REMARKS

Application No. 09/437,418

VERSION WITH MARKINGS TO SHOW CHANGES MADE

FIG. 5

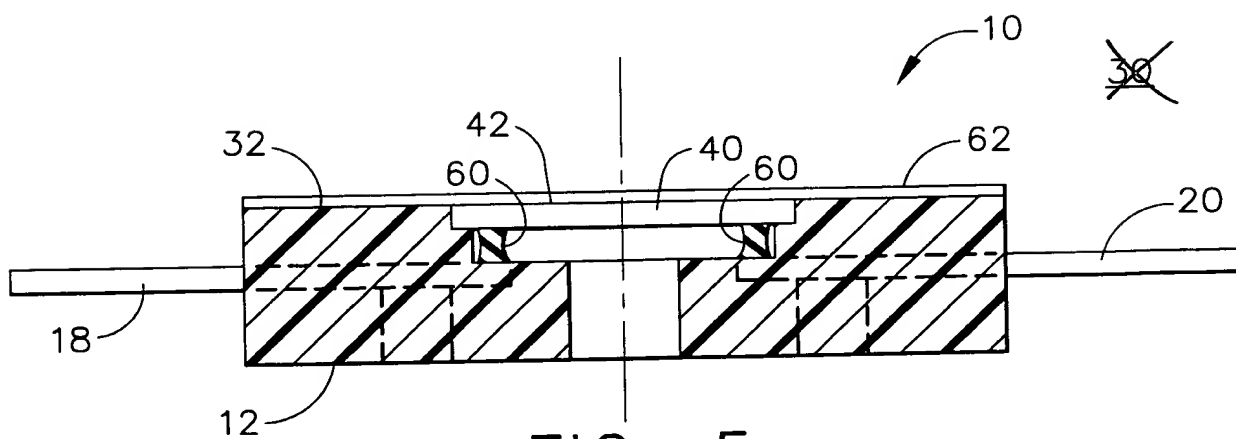
Figure 5 has been amended as follows:

With the concurrence of the Examiner, applicants intend to amend Figure 5 of the Drawing by deleting the reference numeral "30" therefrom as shown by the red ink notation on the accompanying copy of Figure 5.
